UNITED STATES PATENT AND TRADEMARK OFFICE

10/726,182

Office Action Summary	Application No. 10/726,182	Applicant(s) BRANDNER ET AL.	
	Examiner SHAWN M. BRADEN	Art Unit 3781

DETAILED ACTION

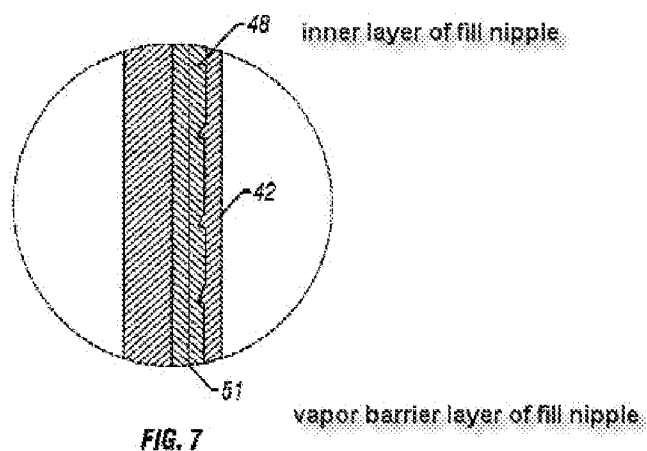
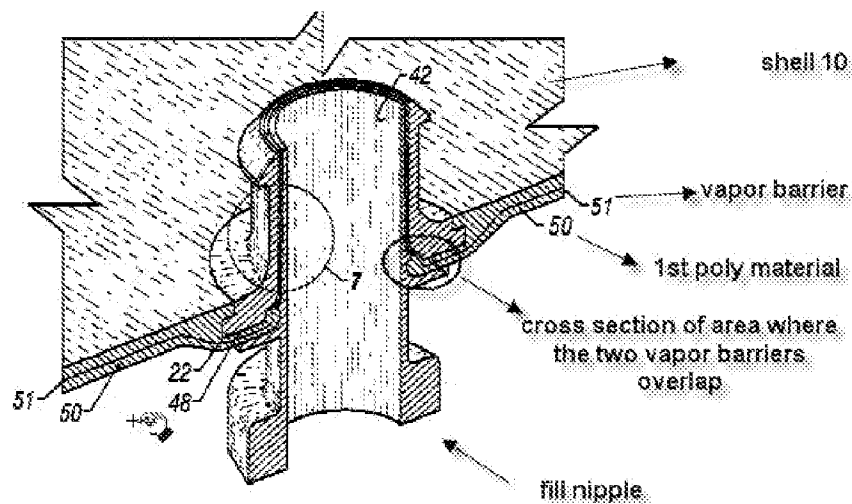
14. In response to applicant's first argument, Potter does not meet the independent claim 23, Please refer to examiner interpretation of Potter below.

The examiners interpretation above clearly shows where in Potter two vapor barriers overlap, layer (51) of the shell being the first layer and also labeled layer (51) of the nipple being the second. In response to applicants comments about page 8 of the office action dated 05/27/2008. The examiner was showing a second interpretation of Potter where the flange 22 also, meets the structure and recitation of "vapor barrier" and

that flange (22) is considered a third vapor barrier layer, thus dually satisfying the claim language of "at least two vapor barrier layers along the entire extent of the overlap of the fill nipple and the shell". Also one can see that this outer layer is of different material by looking at the outer most layer of fig. 7 compared to the inner most material show in fig. 7.

15. In response to applicant's arguments under title Claim 26 and 27, Examiner draws attention to the above interpretation of Potter where the vapor barrier of the shell labeled (51) and the vapor barrier of the nipple (51) are both clearly pointed out. The ellipse callout has been drawn to show the area where the two layers overlap in a separate and spaced relationship.

Fig. 3

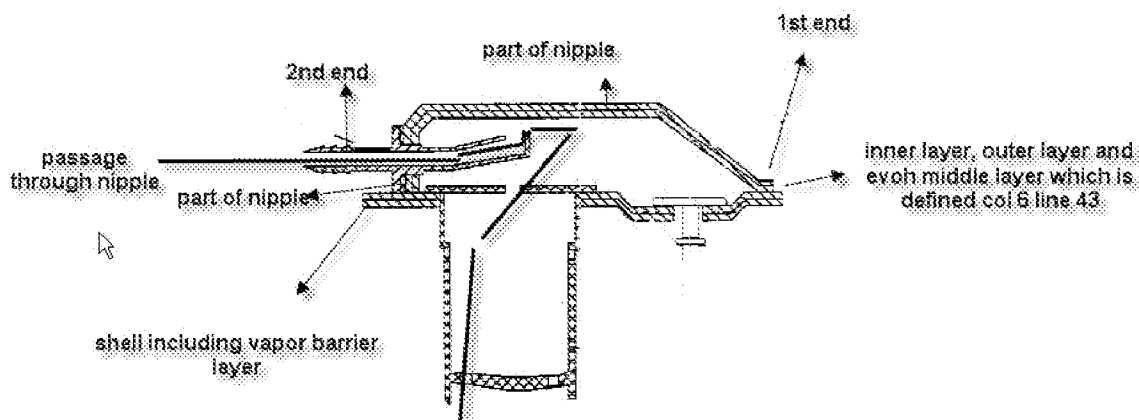
16. In response to applicant's argument under title Claim 9, applicant disagrees with the structure of Van Schafingen's nipple. For clarification examiner views in (fig. 3 as above) the nipple to be from the outer most tip of element 10 until it's connected to the shell, including element 1 having the multi-layer construction layers. The combination would be a embodiment in Van Schafingen's fig 3 with an additional vapor barrier layer (Gerard 109) as taught by Gerard (cover).
